Re: ARC Document Solutions (Formerly City Blue Print)  
RWQCB Case#01-0210  
1700 Jefferson St  
Oakland CA, 94612

RE: Work Plan Addendum  
1700 Jefferson Street, Oakland, California

On behalf of ARC and based on phone conversations, email correspondence, and our on-site meeting with Lance Lo, the apartment building property owner, on July 31, 2015, this email provides the following as an addendum to the *2013 Conceptual Site Model and Work Plan for 1700 Jefferson Street, Oakland, California and Foundation Depth Survey Report*.

**Figure - 1**  
**Proposed Sampling Locations**  
**1700 Jefferson Street, Oakland, CA**

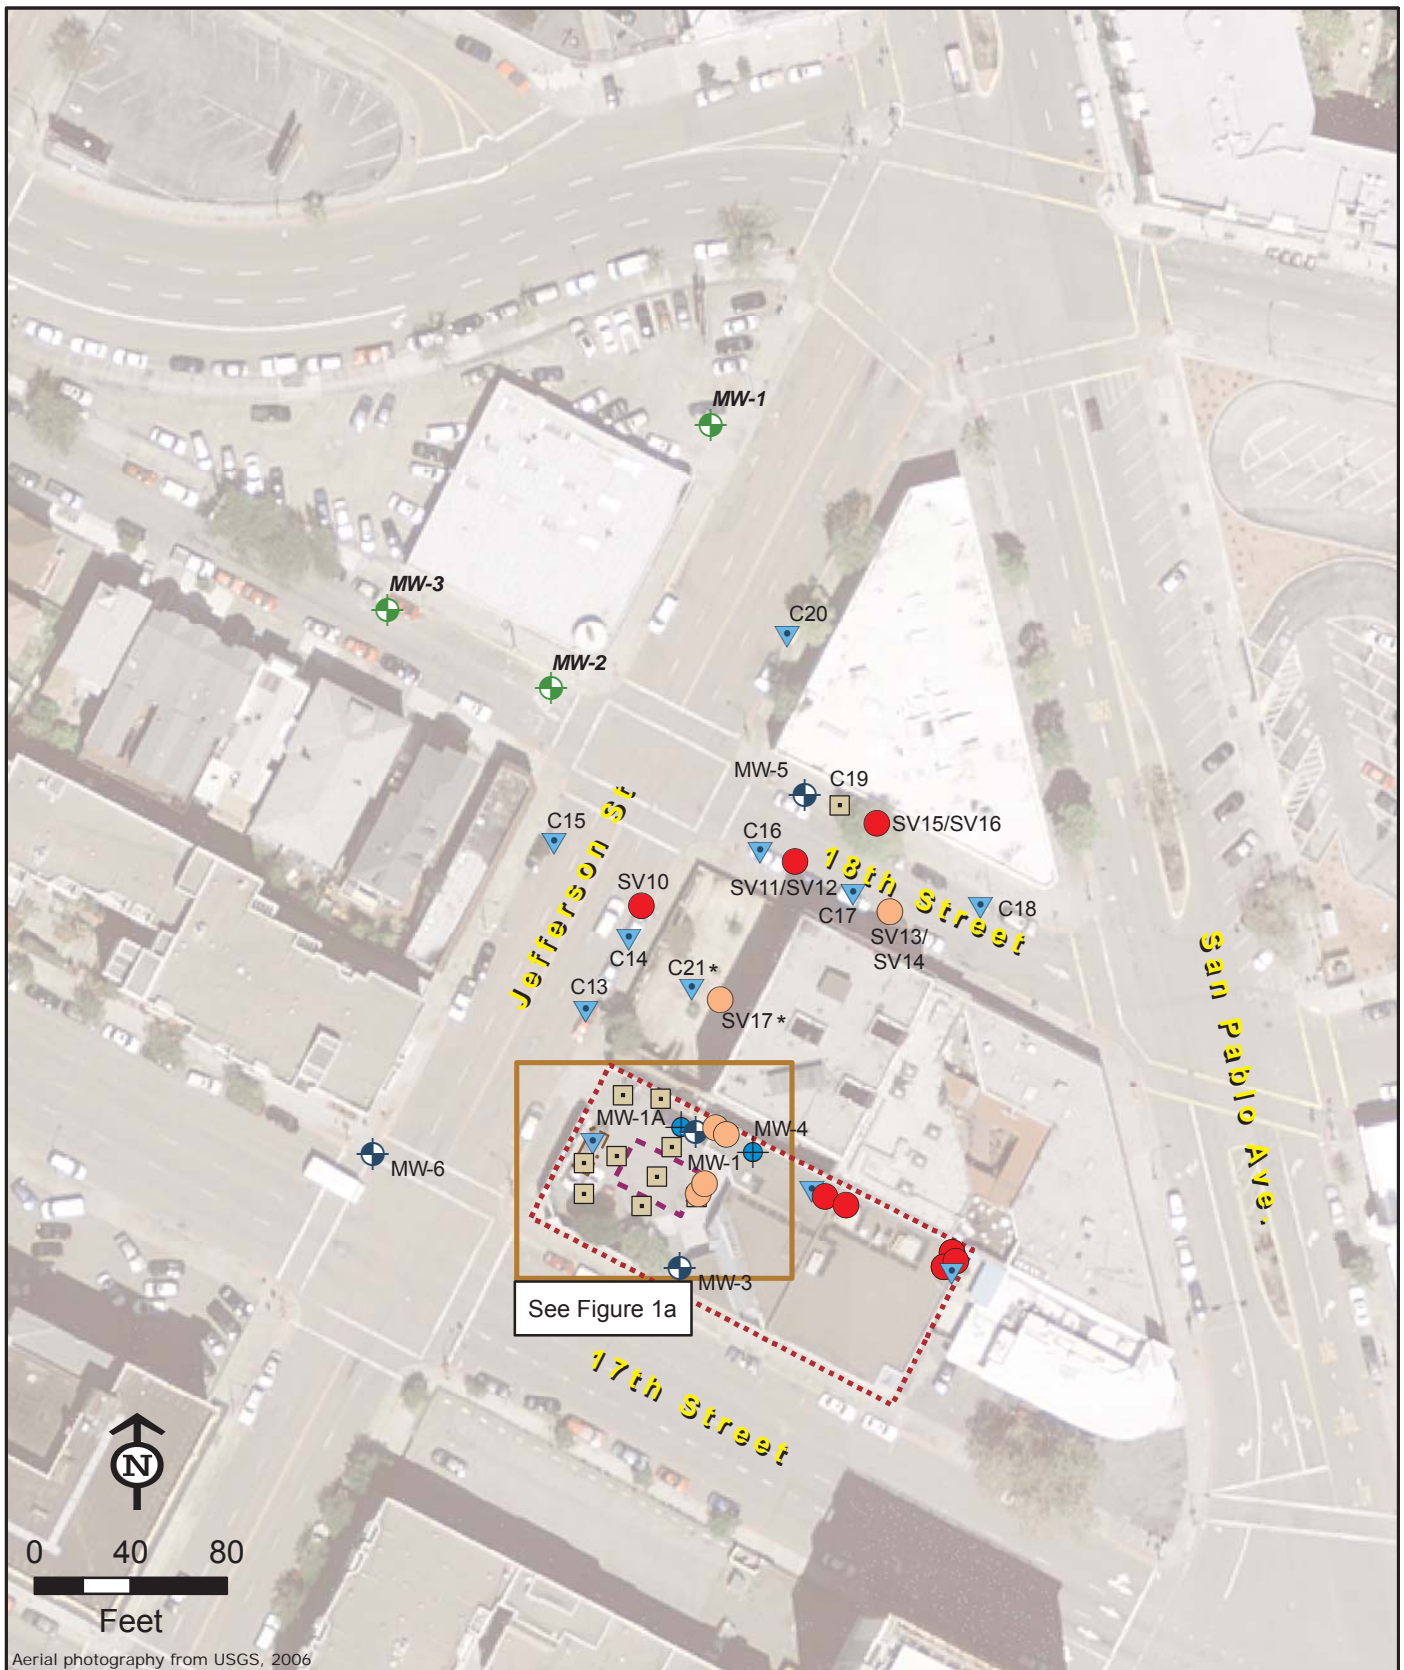
- Table 1 provides the rationale, sample depths, and analyses for each soil boring.
- Table 2 provides the rationale, sample depths, and analyses for each soil vapor location.
- Figures 1 and 1a show the additional borings proposed to be advance.

- Install 7 soil vapor wells at various depths adjacent to the neighboring apartment's courtyard and on the property,
- Advance 10 temporary soil vapor points within the on-site building, on Jefferson St, and on 18<sup>th</sup> Street to assess risks to occupants in the apartment building, on-site building, and neighboring properties,
- Advance one additional boring on-site adjacent to the courtyard to collect soil samples,
- Advance one additional boring on Jefferson Street to sample ground water; and
- Advancing one boring near MW-5, in the area of patch in the sidewalk to collect soil samples and two soil vapor samples from different depths.
